Landscape Referral Response

Application Number:	DA2022/1431
Date:	29/09/2022
Responsible Officer:	Maxwell Duncan
Land to be developed (Address):	Lot 1 DP 28219 , 635 Warringah Road FORESTVILLE NSW 2087 Lot 15 DP 212195 , 633 Warringah Road FORESTVILLE NSW 2087

The application seeks consent for demolition works and construction of seniors housing.

Fig.1 - Extract from rear planting plan indicating rear boundary offsets and garden width.

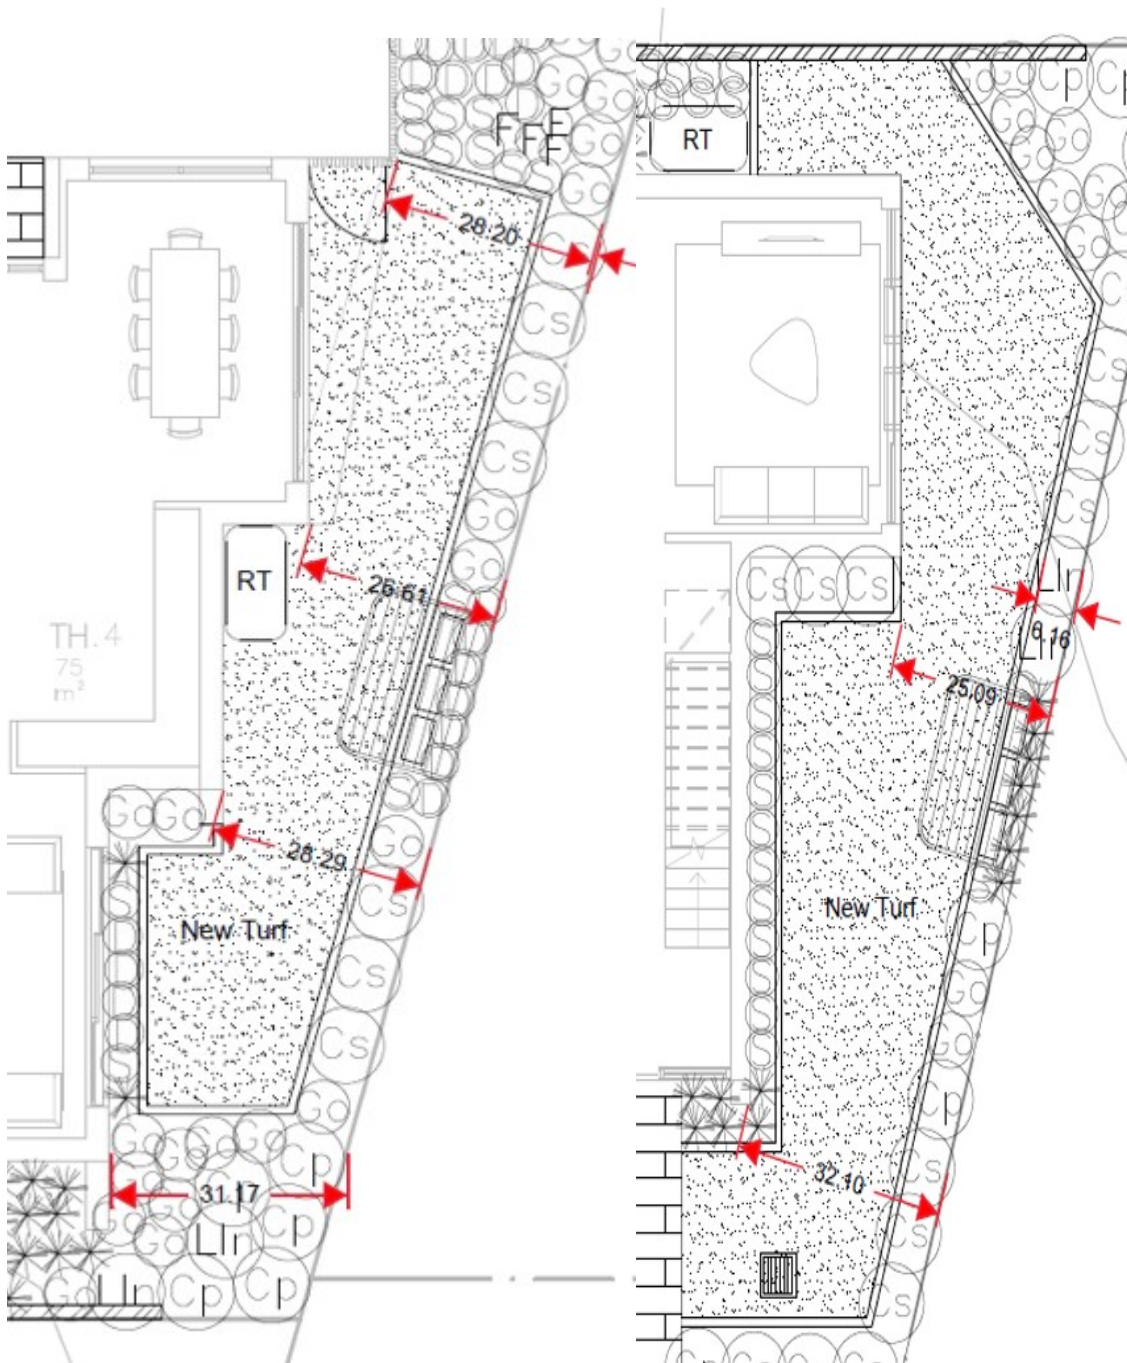
Concern is raised, however, with regard to the rear setback proposed for the development. The SEE indicates a 3m setback from the buildings, however scaled measurement off the plans provided indicate that parts of the buildings are located closer than 3m to the rear setback . Additionally, a large portion of the rear landscape planting is located within narrow garden beds (600mm) and comparatively low or narrow species, unlikely to provide an effective landscape buffer to the adjoining properties. (Fig 1).

It is noted that the DCP requirement for rear setback is 6m.

In consideration of the above, the rear setback is considered too narrow to accommodate private open space and amenity planting in keeping with the character of the area and the provision of adequate buffer between the development and adjoining properties to the rear.

The proposal is therefore unsupported.
